Access Compliance Report

Public Rights-of-Way

(Curb Ramps)

Intersection ID: N/A	Main Street: BYRUM_DR	Cross Street: PINEY_TOP_DR	Location: SW
ADA ID: 018F622C5631	Ramp Type: Perp	Initial Pass/Fail: Fail	Overall Compliance: No
Codes/Mitigation Info/Possible Solution		Field Measurements/Component Compliance

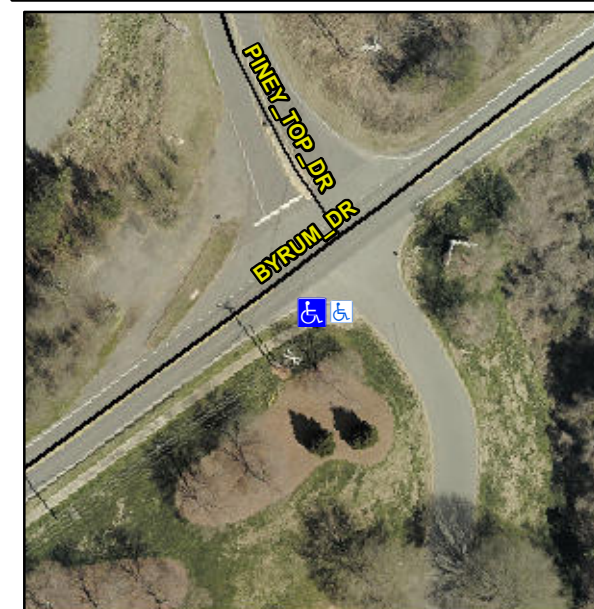
R304.5.1, R304.2.2, R304.5.3

Compliance	Description	Data	Compliance	Description	Data
N/A	Ramp Length (in)	119.0	No	Ramp Slope (%)	9.5
No	Ramp Width (in)	46.0	No	Ramp XSlope (%)	11.3
N/A	Flare Type LT	N/A	N/A	Flare Type RT	N/A
N/A	Flare Slope LT (%)	N/A	N/A	Flare Slope RT (%)	N/A
N/A	Flare Traversable LT?	N/A	N/A	Flare Traversable RT?	N/A
N/A	Landing Length (in)	N/A	N/A	DWS Provided?	N/A
N/A	Landing Width (in)	N/A	N/A	DWS Contrast?	N/A
N/A	Landing Slope (%)	N/A	N/A	DWS Length (in)	N/A
N/A	Landing X Slope (%)	N/A	N/A	DWS Full Width?	N/A
N/A	Landing Curb? (Y/N)	N/A	N/A	DWS Offset (in)	N/A
N/A	Shared Landing?	N/A			
N/A	Gutter Ponding?	N/A	N/A	Gutter Slope (%)	N/A
N/A	Gutter Lip Ht (in)	N/A	N/A	Gutter X Slope (%)	N/A
N/A	Painted X Walk1?	No	N/A	Painted X Walk2?	N/A
	X Walk 1 Direction	To N		X Walk 2 Direction	N/A
N/A	X Walk 1 Width (in)	N/A	N/A	X Walk 2 Width (in)	N/A
	X Walk 1 Slope (%)	8.1		X Walk 2 Slope (%)	N/A
	X Walk 1 X Slope (%)	3.6		X Walk 2 X Slope (%)	N/A

Remove & Replace Entire Ramp.
